The proposal is for the construction of a hip-to-gable roof extension, the erection of rear dormer, and the installation of front rooflights. This would require an application for full planning permission, with a fee of £206. As part of this application, Certificate B should be filled out as the property is not in use as a single dwelling house (assuming that the applicant does not own all the properties within the site boundary, including the other flats within the house). The application would require the following information:

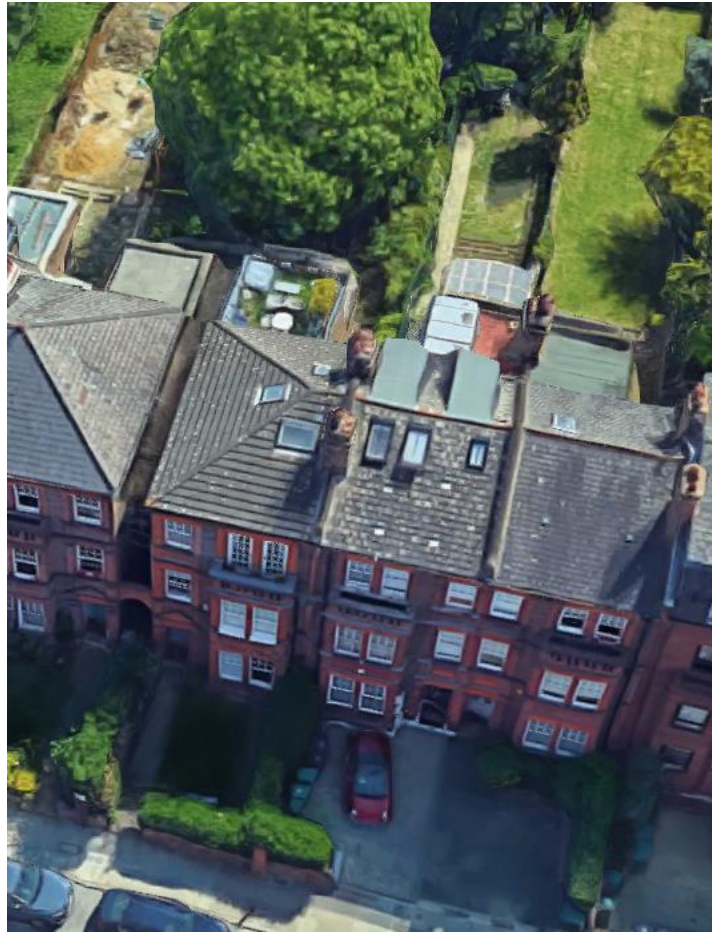
The roof light on the existing street elevation looks too big when compared with what is on Google:

In any event the proposed roof lights on the front roof slope are excessive, uncharacteristic of the terrace and inappropriate on the building in the Conservation Area. These should therefore be reduced in size.

They should also be of a conservation design and materials.

Indicative examples of different types of dormers for properties in Conservation Areas.

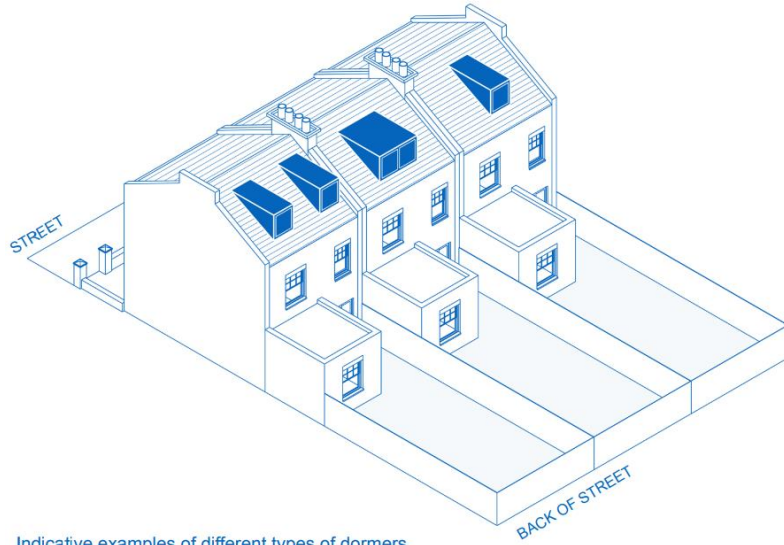
The rear dormer effectively forms a rear roof extension that will need to be reduced in scale by a significant degree in order to be acceptable. The glazing as currently proposed would not match the hierarchy of windows in the rear elevation as it is larger than those below, and the size of the rear roof extension itself would not be subservient to the host property. You may want to consider splitting the rear dormer into two separate dormers similar to the neighbouring property, but the same points apply regarding the glazing and the scale of the roof extension. Please see below a diagram showing examples of appropriate rear dormers in a conservation area, taken from the [‘Home Improvements’ Camden Planning Guidance](#). The easiest way of reducing the scale of the rear dormer/roof extension would likely be to amend the design to a smaller width. The design of the glazing should also match the existing windows in the rear elevation, so my strong recommendation would be to propose timber sash windows that are smaller in scale than the windows below in the rear elevation. The materials of the dormer should also, as far as possible, match the materials of the property so as not to harm the character of the building and surrounding area.
